**APPEAL #1**

**CONCEPT SUBDIVISION STAFF ANALYSIS REPORT**  
*(As of August 5, 2025)*

CASE NO.: 2025-4297-TP

PROPOSED SUBDIVISION NAME: Piney Ridge Estates

**EX 2**

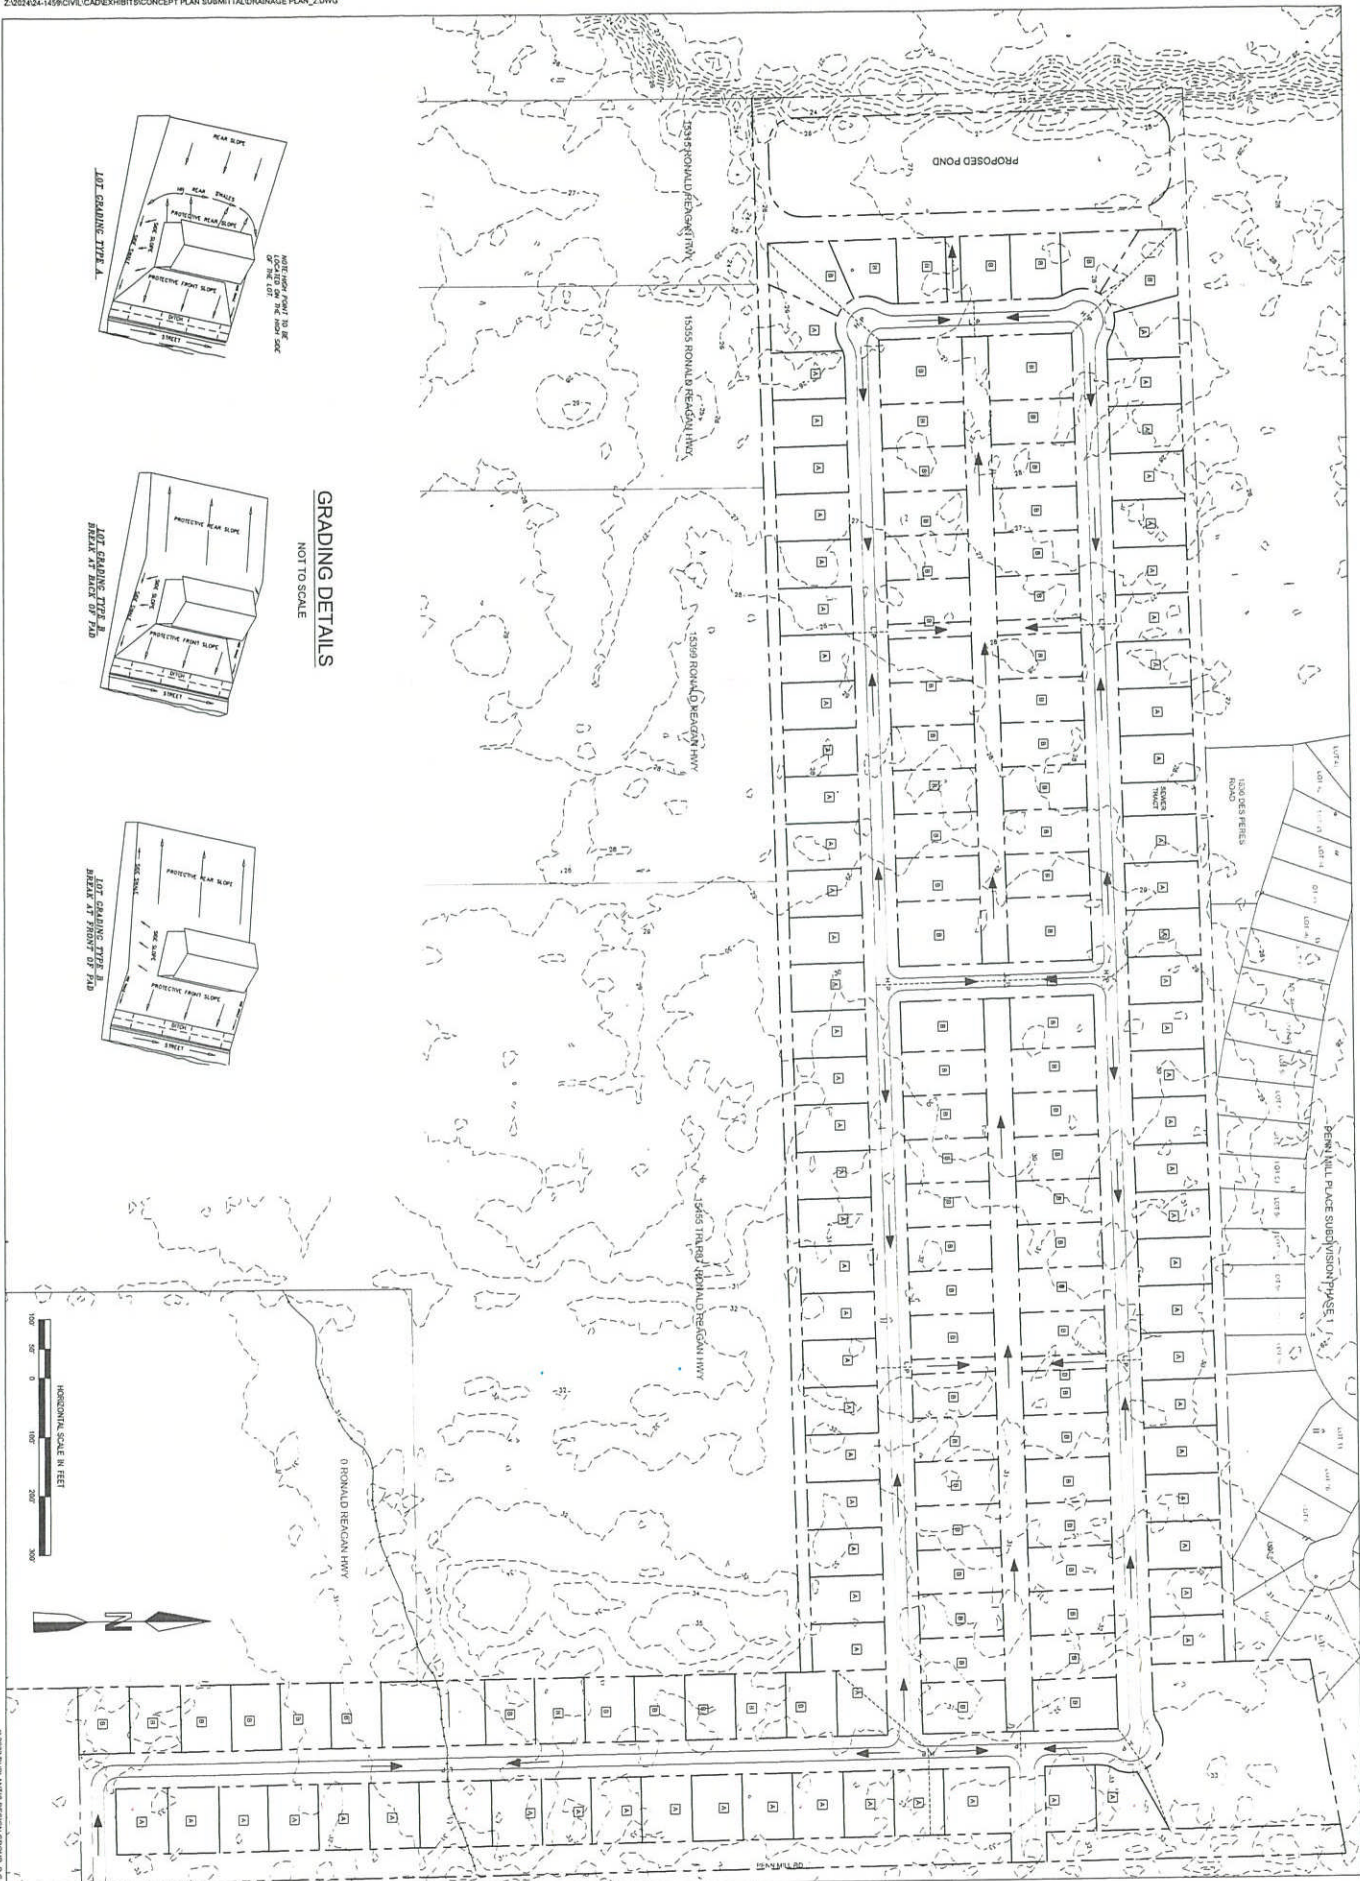
2. The Concept Plat needs to be updated to reflect and account for the previous comments and markup summary issued to the developer and the engineer of record on August 5, 2025.
